TO: Mayor and Members of City Council  
FROM: Brent N. Damman, Zoning Administrator  
SUBJECT: Recommendation from the City Planning  
Commission to approve a Special Use Permit  
for Henry County Schools.  
MEETING DATE: December 16th, 1991 7:00pm  
HEARING #: PC 91/23

RE: Modular Classroom Installation  
West Elementary School

Re: Mobile Unit  
West Elementary School

This letter will serve as our review of Plan Sheets A-1 and A-2 of the above referenced project, and our review comments are as follows:

## INSTALLATION INSTRUCTIONS FOR STYLE "CB" SEWER SADDLE

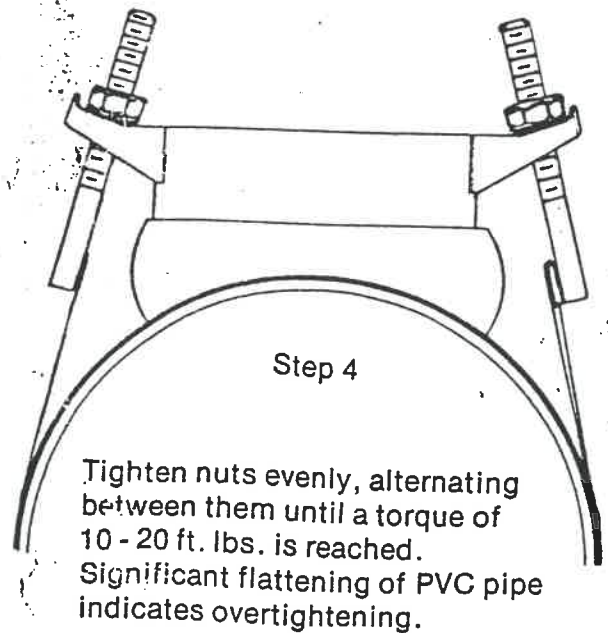
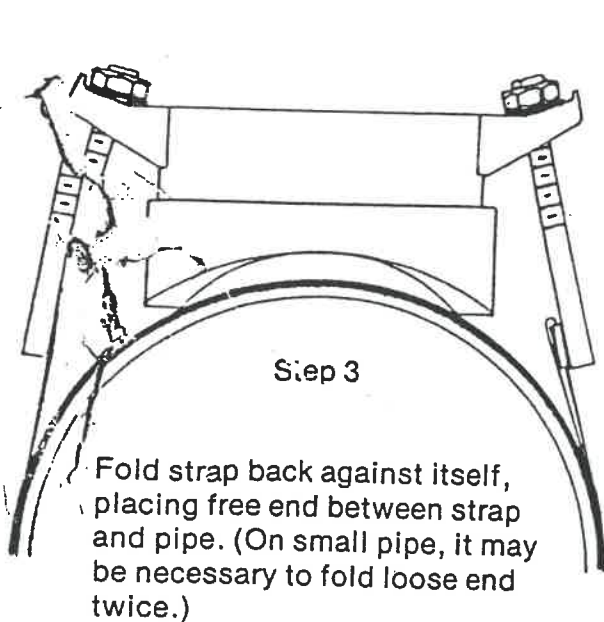
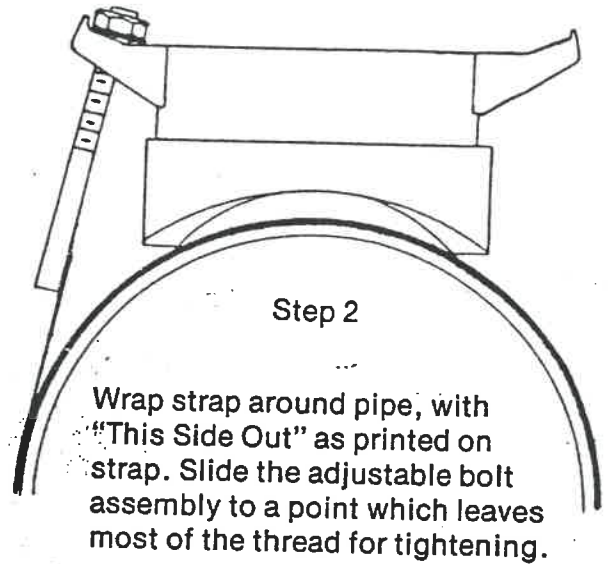
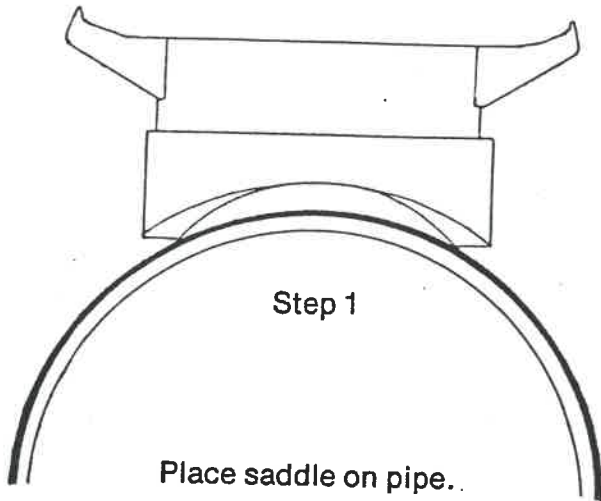
- 1) The sanitary sewer shall be laid at a minimum grade of 0.6% and the tap into the existing sanitary sewer line shall be made with a saddle tee as manufactured by Romac Industries, Inc. (see attachment). A Sewer Tap Permit and fee must be filed with the City of Napoleon Engineering Department (Mr. Brent Damman).
